MINERALS PROGRAM INSPECTION REPORT
PHONE: (303) 866-3567

MINE NAME: Lamar Pit	MINE/PROSPECTING ID#: M-1987-079	MINERAL: Sand and gravel	COUNTY: Prowers
INSPECTION TYPE: Monitoring	INSPECTOR(S): Amy Eschberger	INSP. DATE: October 20, 2021	INSP. TIME: 14:45
OPERATOR: All-Rite Paving & Redi-Mix, Inc.	OPERATOR REPRESENTATIVE: Mario Ambrosio	TYPE OF OPERATION: 112c - Construction Regular Operation

M-1987-079 / Lamar Pit / All-Rite Paving & Redi-Mix, Inc. (112c)

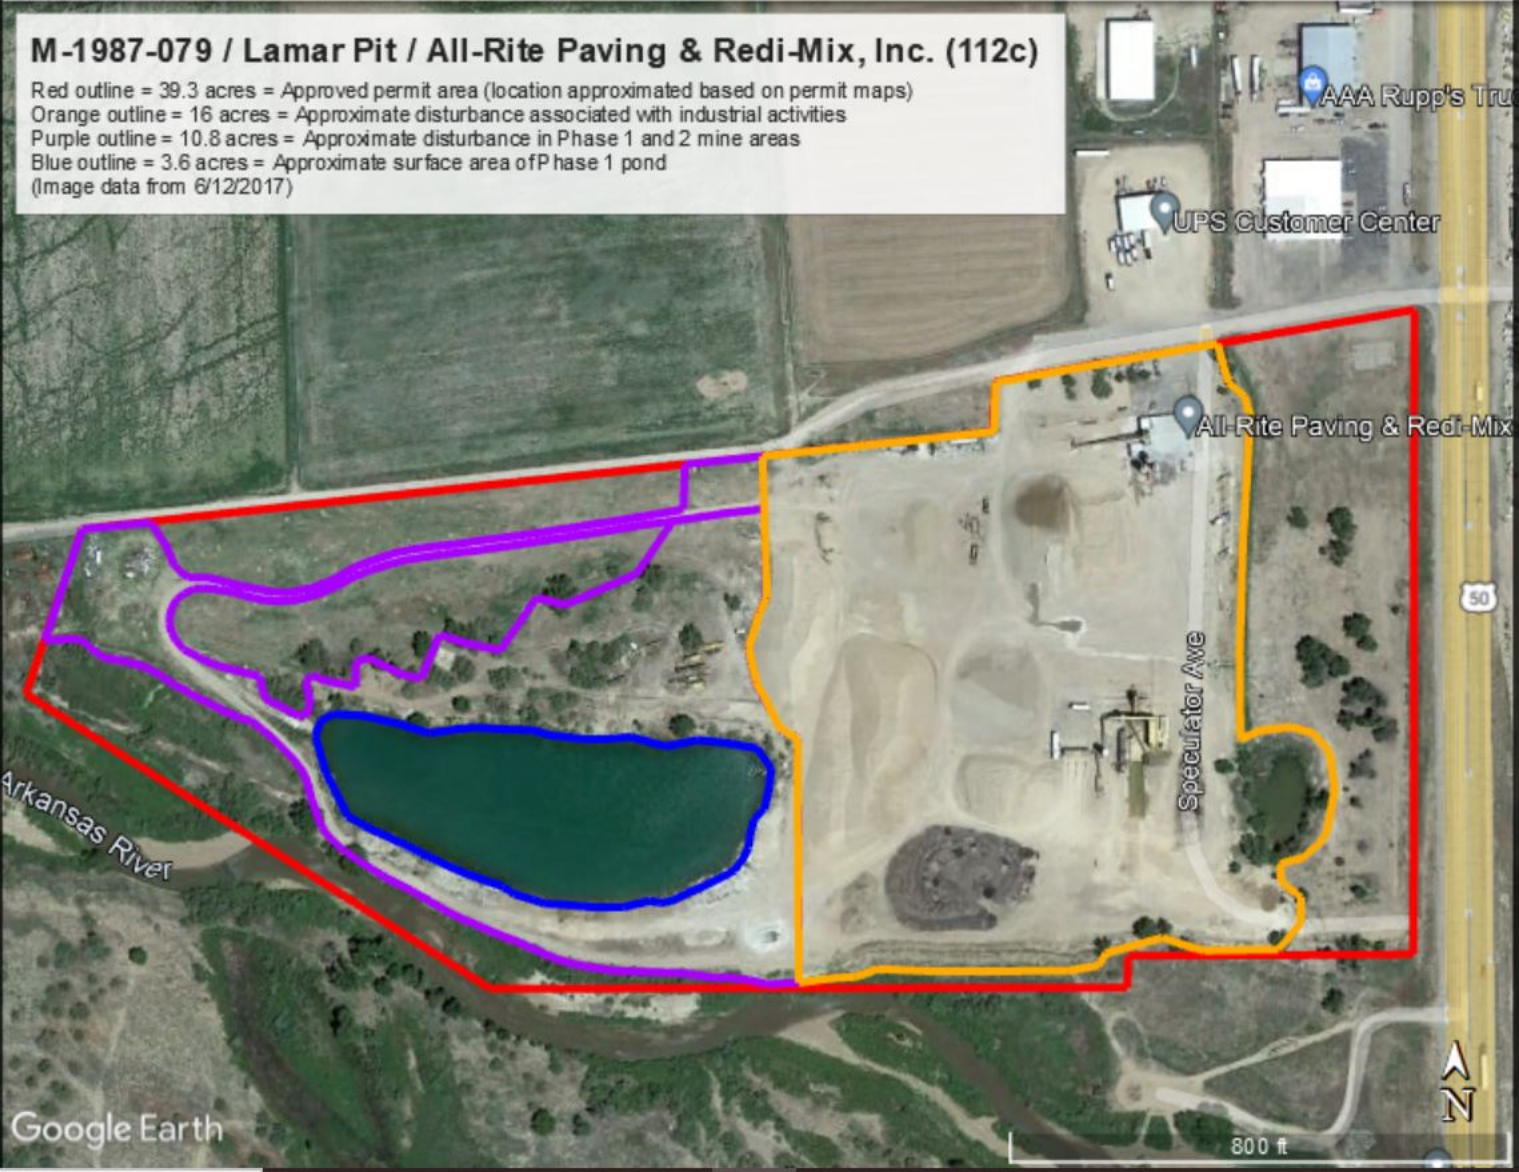
The Division estimates a total of 26.8 acres of disturbance exists at the site, of which, 16 acres is associated with the industrial yard, and 10.8 acres is located in the Phase 1 and 2 mine areas (Phase 1 pond + areas adjacent to pond + access road + equipment storage and trash/debris storage areas). As mentioned above, the Phase 1 pond has an estimated surface area of 3.6 acres. According to the Division's last inspection report (for the 1/22/2015 inspection), an augmentation plan is in place for this site under the Lower Arkansas Water Management Association (LAWMA) for up to 3.8 acres of exposed groundwater. This would mean the operator is in compliance with the Colorado Division of Water Resources with regard to the amount of exposed groundwater at the site.

RECLAMATION PLAN MAP

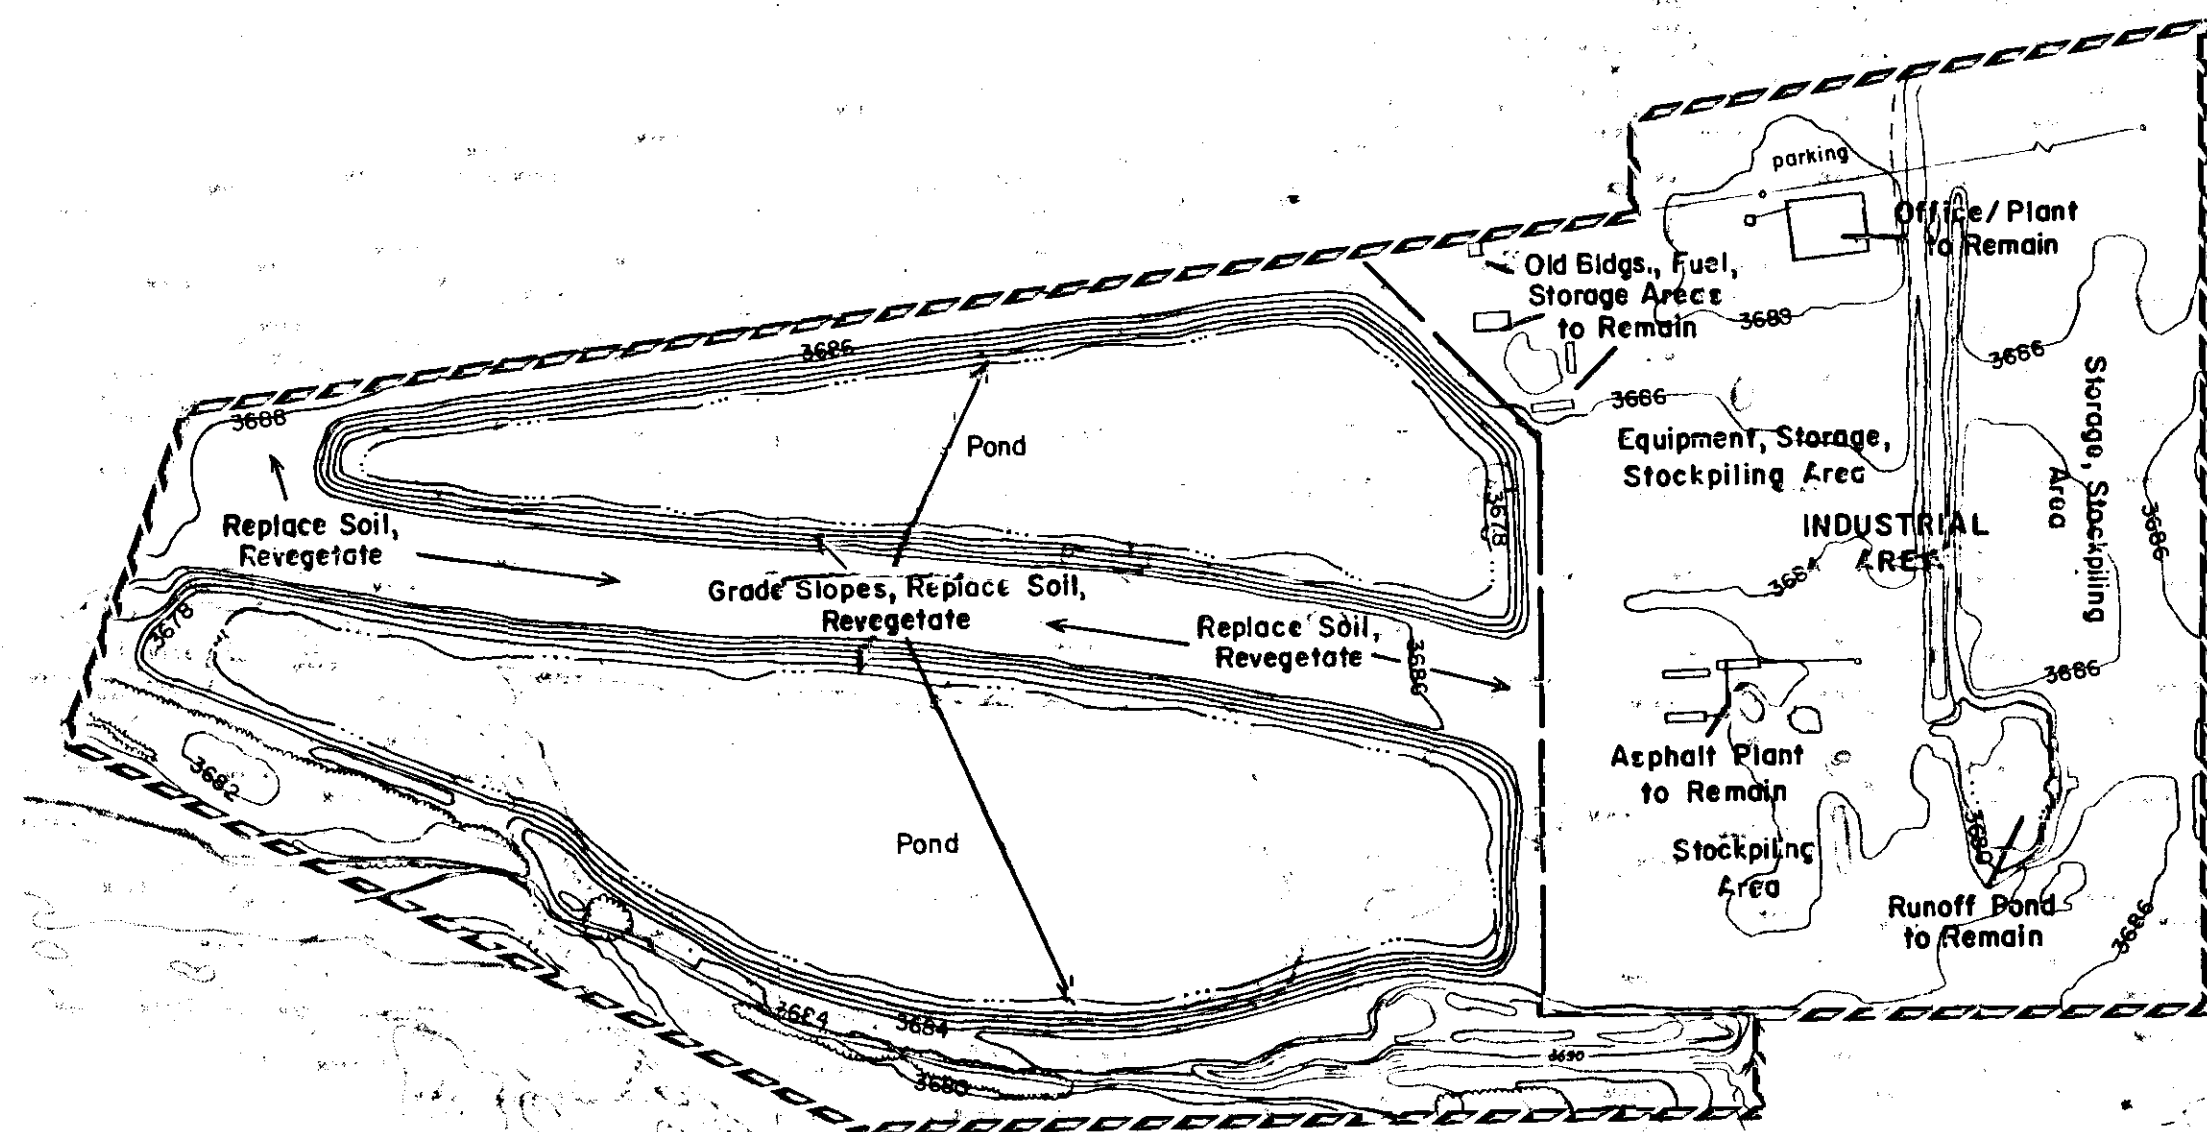
- 1) The approved reclamation plan calls for leaving a 13.8 acre industrial/commercial area. However, the operation is currently utilizing more than 13.8 acres for this purpose. The Division estimates disturbance associated with plant operations (in the eastern portion of the permit area) to cover approximately 16 acres. The operation is also using portions of the Phase 2 mine area for equipment and trash/debris storage. The operator must specify which areas will remain for industrial/commercial use and which

- 2) It appears that only one pond (in Phase 1), rather than two, will remain for reclamation. The operator will need to specify the location and approximate surface area of any ponds to remain.

- 3) It is not clear which portions of the disturbed area have exposed concrete at the ground surface and how these areas will be reclaimed. The operator will need to specify which areas have exposed concrete and clarify how these areas will be reclaimed. Will the concrete be ripped up prior to retopsoiling and revegetating these areas? If not, is there sufficient topsoil available on site to place 2-3 feet of topsoil on these areas prior to revegetation?

- 4) It is not clear whether the road present in the Phase 1 and 2 mine areas will remain for reclamation. The operator will need to specify any roads to remain.

with the required \$216 revision fee, to update and clarify the current approved reclamation plan to reflect existing and proposed activities. Specifically, the reclamation plan and reclamation plan map need to be updated to specify areas to remain for industrial use and areas to be reclaimed for rangeland use, specify the location and approximate surface area of any ponds to remain, specify any areas with exposed concrete at the ground surface and clarify how these areas will be reclaimed, specify any roads to remain, identify the location of any topsoil stockpiles on site, and clarify whether sufficient topsoil is available on site to complete reclamation. This revision shall also include an updated bond estimate and a timeline for completing final reclamation at the site. The updated reclamation plan must meet all applicable requirements of Rule 6.4.5. The updated reclamation plan map must meet all applicable requirements of Rules 6.2.1(2) and 6.4.6. The updated bond estimate must comply with Rule 6.4.12.
